ALAMEDA COUNTY
HEALTH CARE SERVICES

Subject: Toxics Case RO0002918, Jordan Ranch, 4233 Fallon Rd., Dublin, CA 94568

Subject: Technical Comments
Jordan Ranch
4233 Fallon Road
Dublin, California

SITE PLAN
Jordan Ranch
4233 Fallon Road
Dublin, California

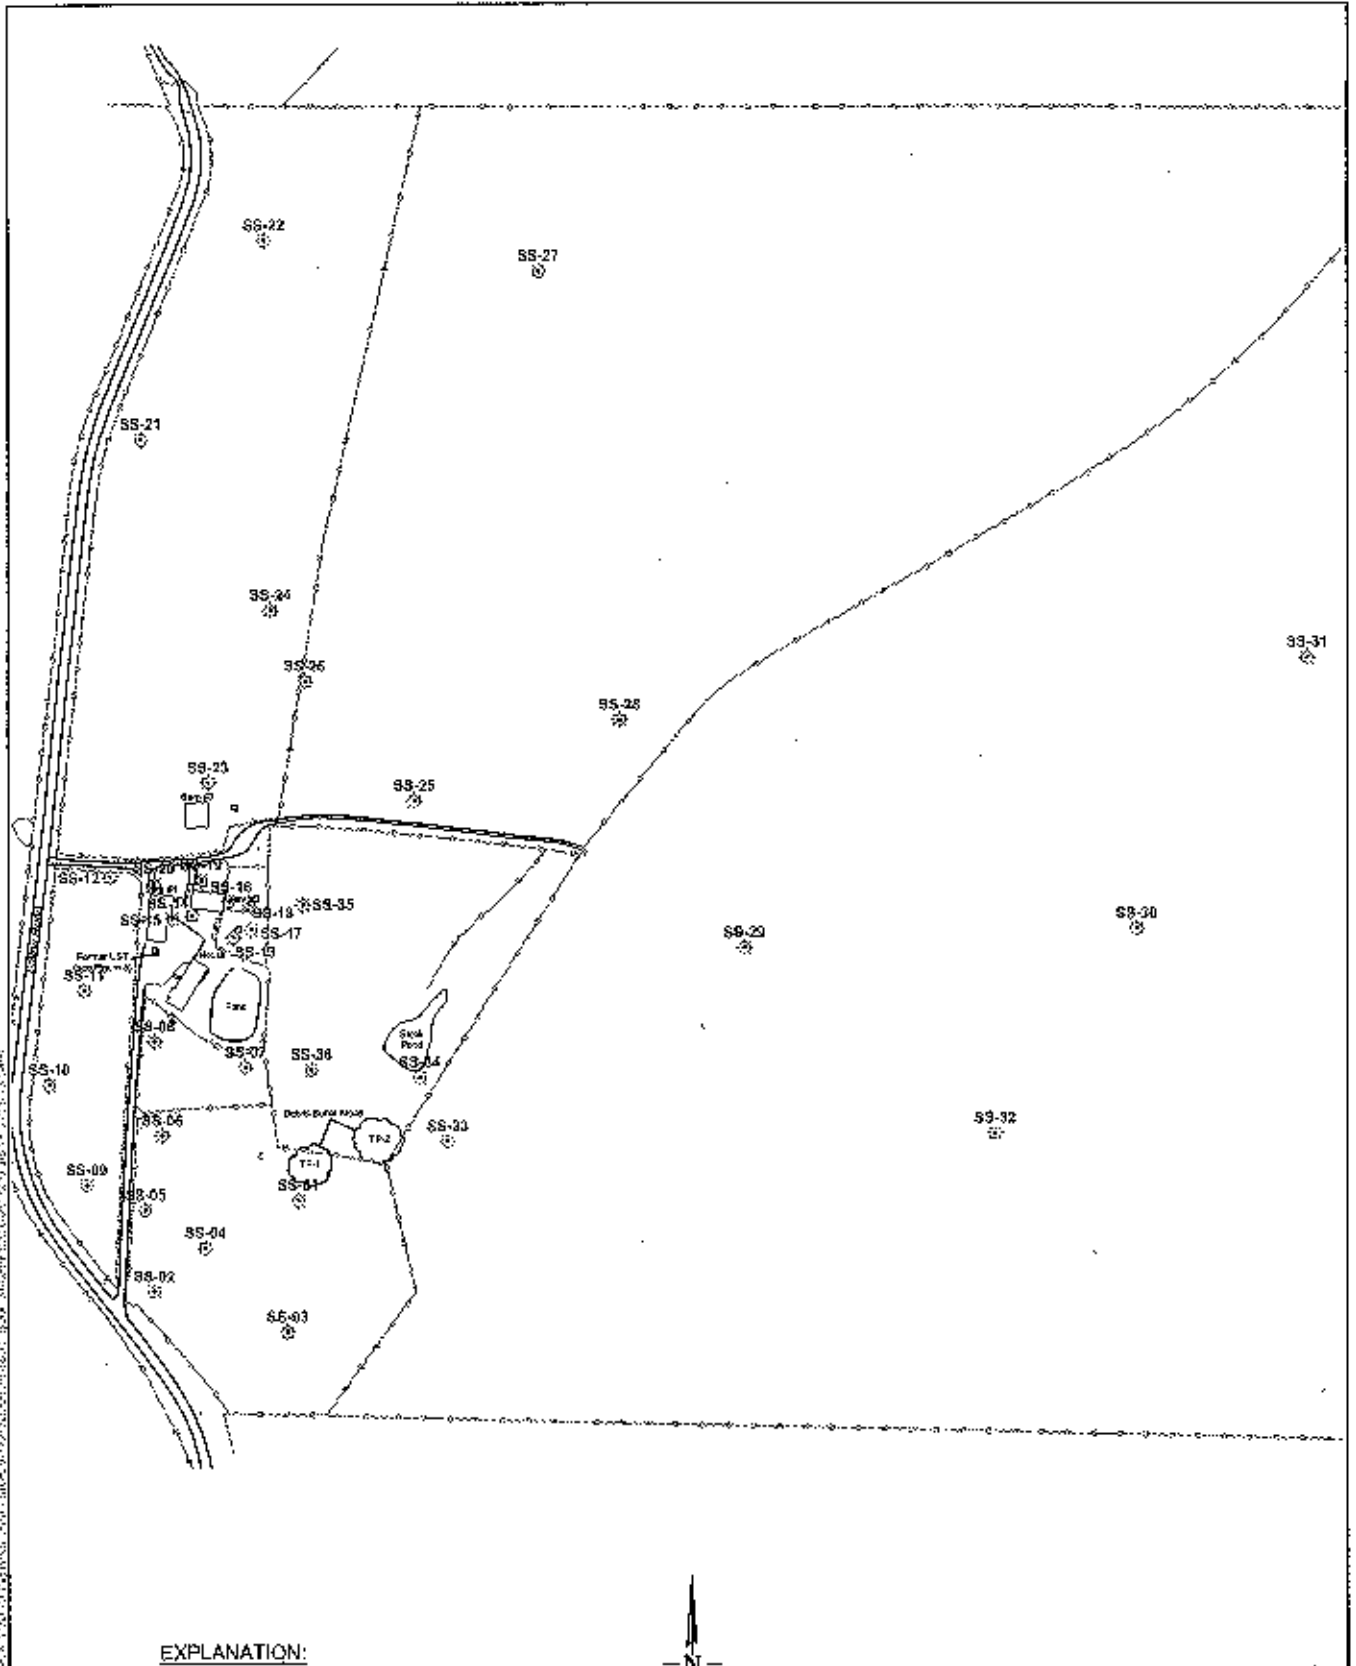
4. Other Areas of Potential Concern- In addition to the well requirements of comment #3, please provide our office with the results of soil analysis of the sample collected from the base of the power pole and from beneath each of the stained areas as requested.

4. The Northgate report appears incomplete. A figure indicating the locations of the shallow soil sample collected for pesticides and herbicides analysis was not included. In addition, analysis of soil samples from the borings for monitoring wells MW-1-MW-5 was not provided. Please provide this additional technical information.

3. The supply well located approximately 300 feet northeast of the ranch house and the two septic tanks are currently operational and still being used by occupants of the Site. These items will be removed prior to development of the Site. A soil sample has been collected at the base of the power pole transformer and sent to McCampbell Analytical Laboratory of Pacheco, California. The soil sample will be analyzed for polychlorinated biphenyls. Visible oil stains beneath the heavy equipment and 55-gallon drums will be removed during remedial activities. A minimum of one sample will be located at each stain location to document the adequate removal of the petroleum-affected soil. The approximate location of these areas are shown in Figure 1 (Attachment B). The circular zones identified in aerial photographs were areas that were used to exercise horses.

4. The locations of the shallow soil samples that were collected and analyzed for pesticides and herbicides by Northgate Environmental Management, Inc. (NEM) is included in Figure 1 (Attachment C). Based on a telephone conversation with Mr. Dennis Laduzindky of NEM, soil samples were not collected during the construction of monitoring wells MW-1 through MW-5.
